Technical Service Information

THM 3T40 (125C) TCC SHUDDER

Figure 1

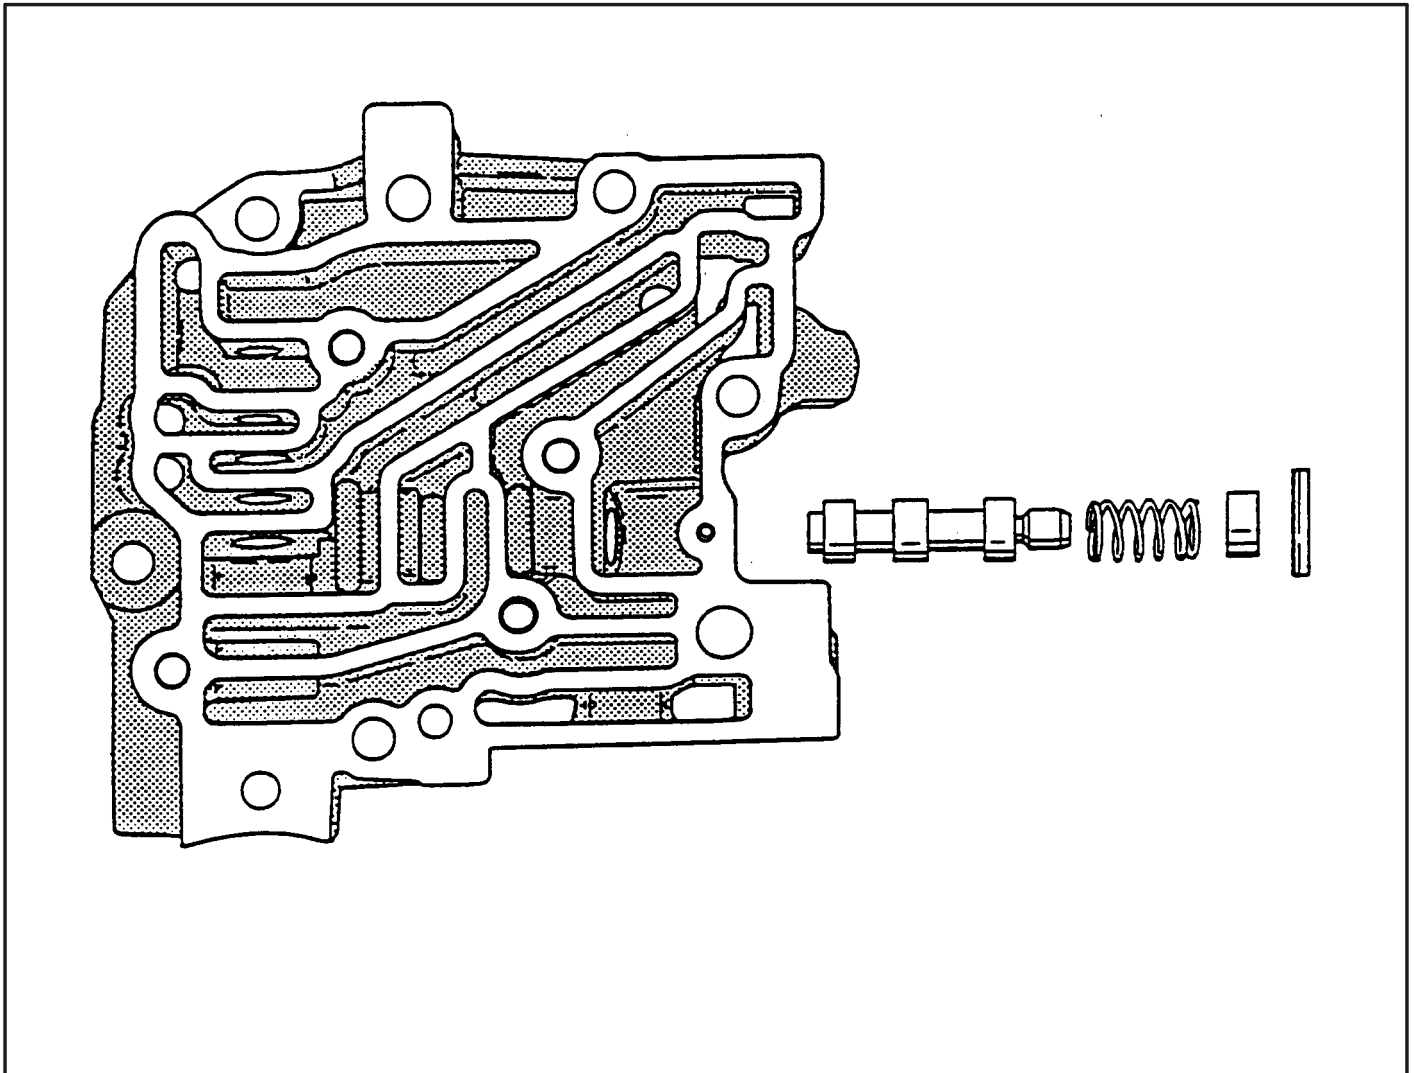
COMPLAINT: Converter clutch shudder

CAUSE: One cause can be low converter regulator charge pressure, Figure 1, Another cause can be slow drain of converter oil in front of clutch piston,

CORRECTION Install stronger regulator valve spring 8637887 or use a spring from a THM 400 forward or direct clutch retainer Figure 2. Drill converter exhaust hole in separator plate to .080".
